Re: Fossil Ridge POADP # 659

The City Staff Development Review Committee has reviewed Fossil Ridge Preliminary Overall Area Development Plan # 659. Please find enclosed a signed copy for your files. Although your plan was accepted, please note the following:

Re: Fossil Ridge POADP

FOSSIL RIDGE SUBDIVISION
P.O.A.D.P./ P.U.D.

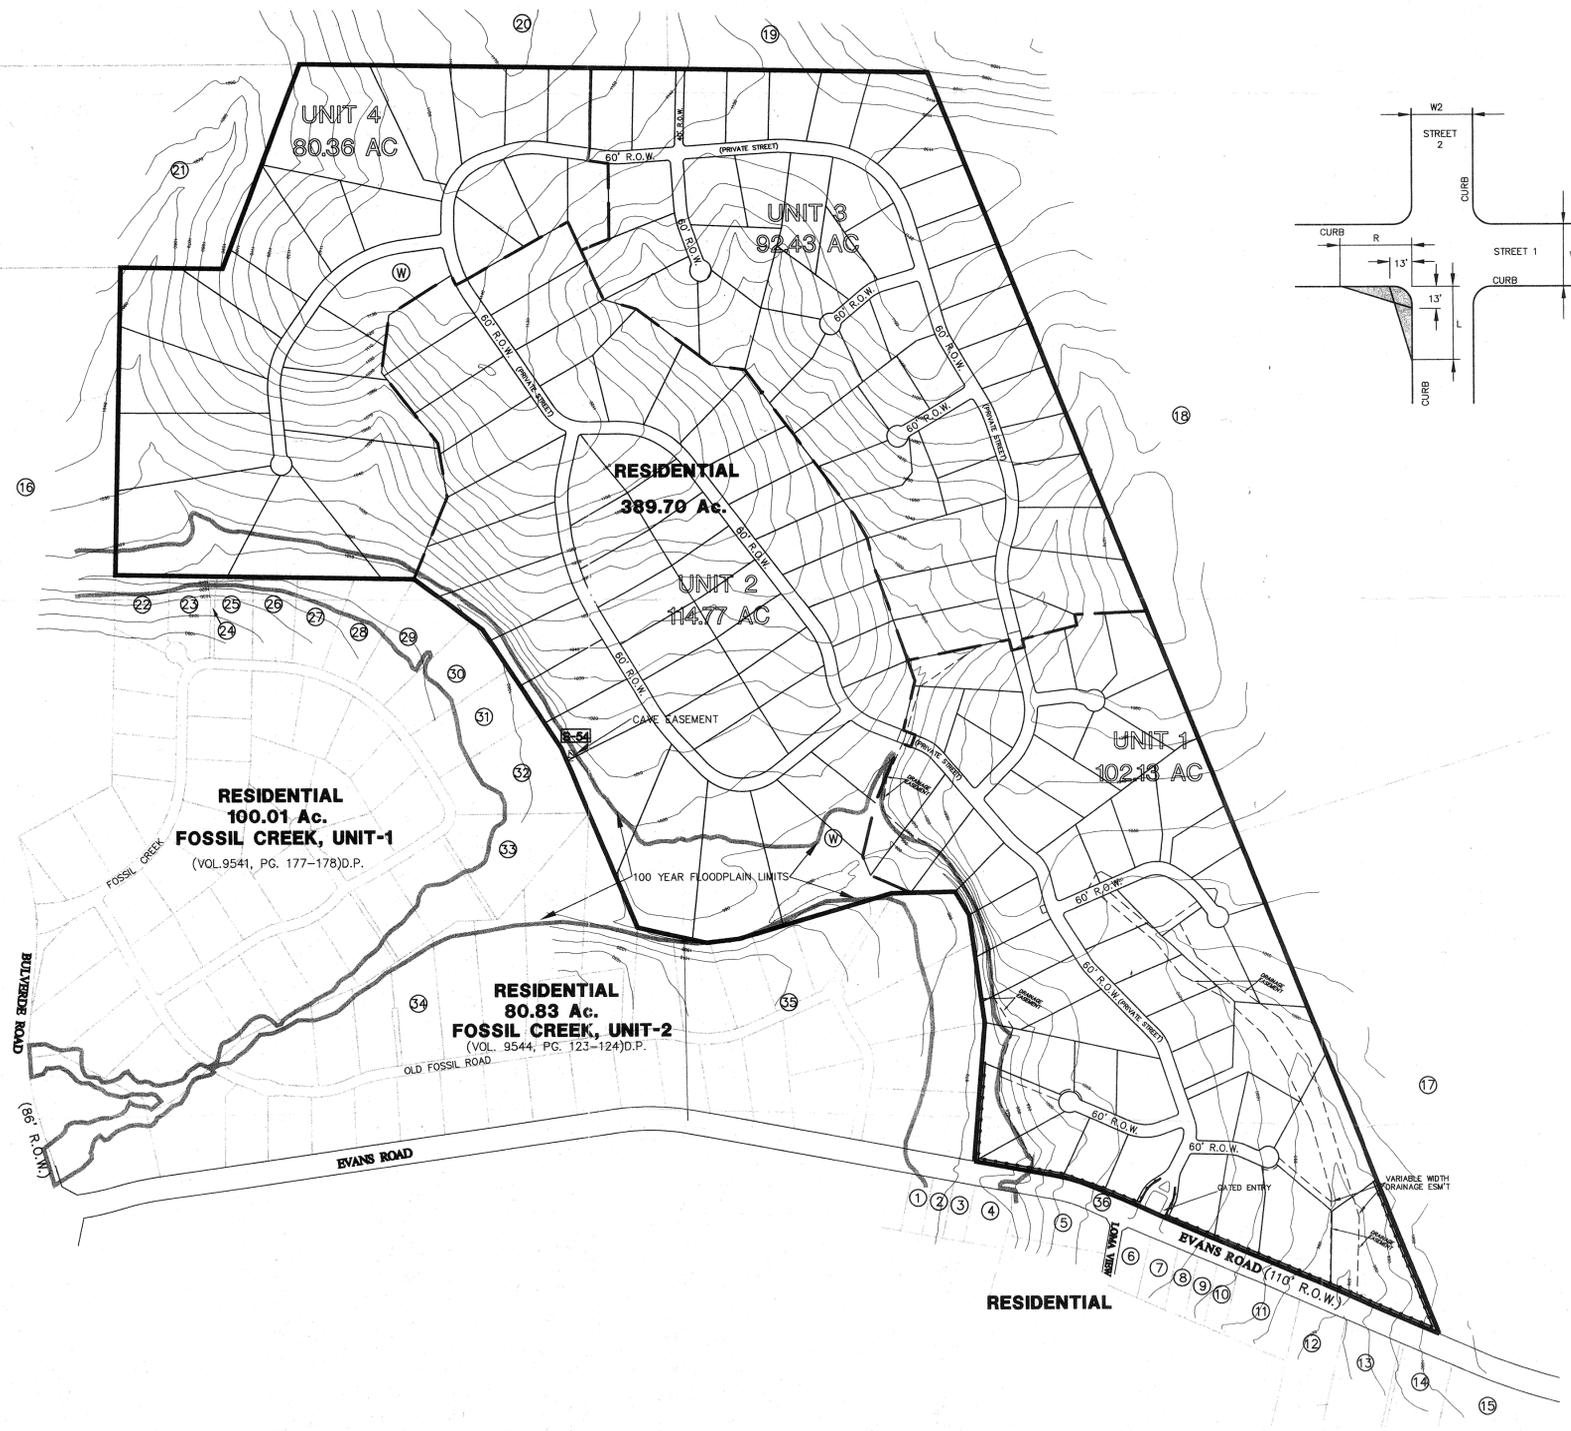
- Based on the topography, a Flood Plain Study and drainage review will probably be required during the platting process. Bexar Co. Public Works will require base flood elevations at the plat level.

- In consideration of public safety and convenience, excessive grades by reason of topography should be avoided in street layouts and arrangements.
- This development will probably need to conform to requirements associated with development over the Edwards Aquifer. For additional information about these requirements you can contact SAWS at 704-7305.

- Access and R.O.W. issues along State facilities will need to be resolved with the Texas Department of Transportation (TXDOT). For information about these requirements you can contact TXDOT at 615-5814.

- This development will need to comply with tree preservation ordinance #85262. For information about these requirements you can contact Building Inspections at 207-7102.

- It will be expected that you will plat all of the property depicted in your POADP, to include: floodpains, drainage areas and open space.
- I would encourage you to work closely with the school district, so that they can plan accordingly.

Fossil Ridge is out of an approved and validated POADP, Evans Tract #452. That POADP was accepted on January 20, 1995. A plat out of that POADP, # 960245, was approved on July 10, 1996. The site encompasses 1691 acres located at the northeast corner of Evans Rd. and Bulverde Rd. This plan shows three entrances into the area now identified as Fossil Ridge. One on the north side from proposed Marshall Rd. which traverses the entire POADP. One from Bulverde Rd. on the west side and one from proposed O'Connor Rd. on the east side. In lieu of these three entrance points previously approved, staff will accept the proposed entrance from Evans Rd. but must ask for another entrance from the north as shown in the Evans Rd. Tract POADP. Your POADP cannot be accepted until another access is shown on the plan.

The City Staff Development Review Committee has reviewed Fossil Ridge proposed Preliminary Overall Area Development Plan. The plan cannot be accepted at this time. A fax memo sent to you outlined several concerns addressed by the POADP committee: alignment of O'Connor Rd.; access to other residential developments adjoining this tract; only one entrance to service 158 lots; and, alignment of your entrance with Loma View.

Fossil Ridge is out of an approved and validated POADP, Evans Tract #452. That POADP was accepted on January 20, 1995. A plat out of that POADP, # 960245, was approved on July 10, 1996. The site encompasses 1691 acres located at the northeast corner of Evans Rd. and Bulverde Rd. The plan shows the O'Connor Rd. alignment north of Evans Rd following a creek bed and traversing Lot 4 located at the entrance to your development. This alignment is not feasible due to existing development on the south side of Evans Rd. Therefore, your POADP is correct in not showing this alignment of O'Connor Rd. The Evans Rd. Tract POADP will have to be revised to reflect the correct alignment of O'Connor Rd.

The Evans Rd. Tract POADP does show three entrances into the area now identified as Fossil Ridge. One on the north side from Marshall Rd. which traverses the entire POADP. One from Bulverde Rd. on the west side and one from O'Connor Rd. on the east side. In lieu of these three entrance points previously approved, staff will accept the proposed entrance from Evans Rd. but must ask for another entrance from the north as shown in the Evans Rd. Tract POADP. Your POADP cannot be accepted until another access is shown on the plan.

Public Works has issued a release for Fossil Ridge. They did not indicate they still have concerns with the alignment of your entrance with Loma View on the south side of Evans Rd.

REVISIONS:
 12/17/99 UPDATED PER CITY COMMENT
